APPROVED MEETING MINUTES

October 1, 2015

Northgate Station Garage

Design Development

Figure 3: South (top) and west (bottom) elevation section of proposed parking garage

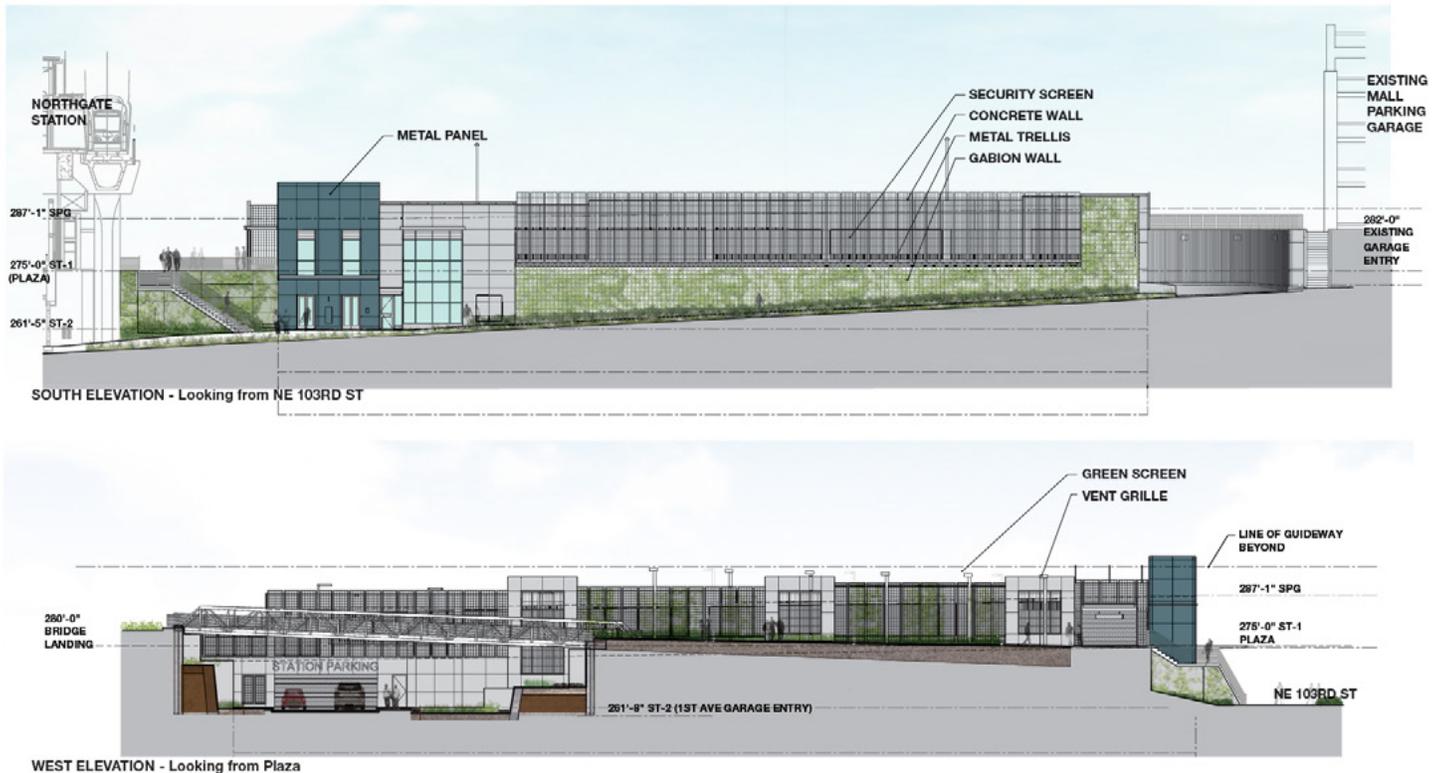
The LRRP appreciates the material and landscaping choices used to screen the garage façade along NE 103rd Street and 1st Ave. While the aluminum material used for the pedestrian bridge may appear too heavy, the Panel agrees that it will provide visual contrast against both the concrete pillars under the light rail station as well as the surrounding vegetation. The design team should consider using a lighter material, such as stainless steel, which will appear lighter while providing the same contrast as the aluminum material. The Panel is also concerned with the use of aluminum decking, which may feel uncomfortable for cyclists using the bridge, and encouraged the design team to think about the experience for all users.

- Continue to explore the structural material used to build the pedestrian bridge while taking safety and appearance into consideration
- Continue developing the public artwork plan
- The LRRP recommends the proposed treatment of the façade and setback along 103rd Street be accepted as meeting MUP zoning code requirements.

Figure 4: Proposed plaza site plan

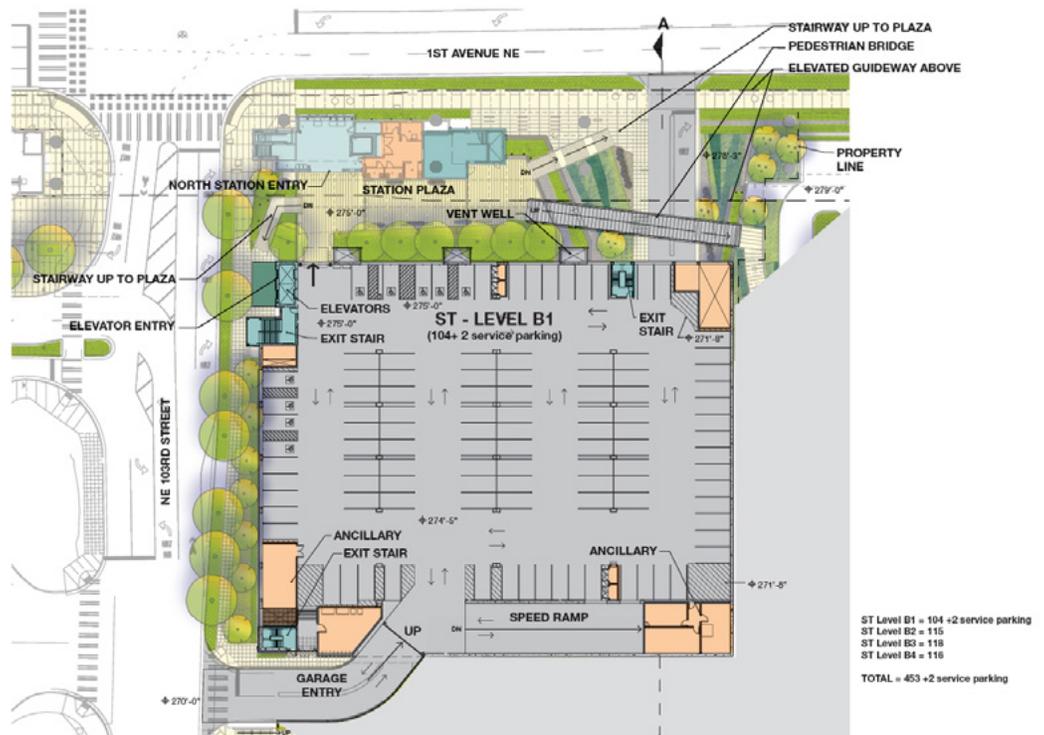
Although the LRRP appreciates the design team's extensive use of landscaping around the garage, they are concerned with the installation and ongoing maintenance of the vegetated areas. The design team has emphasized how the

landscape will play a large role in providing contrast with the garage façade and as well as creating a positive pedestrian experience, both of which can be negatively affected if plants do not fully develop due to poor soils and limited maintenance.

Panel members understand how the top level of the parking garage could be considered both rooftop and surface level parking. Although it appears elevated from three sides of the project site, the northern edge of the parking lot is level with the Northgate Mall entrance, which reads as a surface parking lot within the pedestrian experience. The Panel encourages the design team to soften the northern edge of the parking lot with landscaping and lighting as well as other materials that will positively affect the pedestrian experience.

- Improve the landscaping and lighting design on the top floor of the garage to improve the pedestrian and user experience between the garage and the mall entrance
- Return to the LRRP for an administrative review of the public artwork proposal
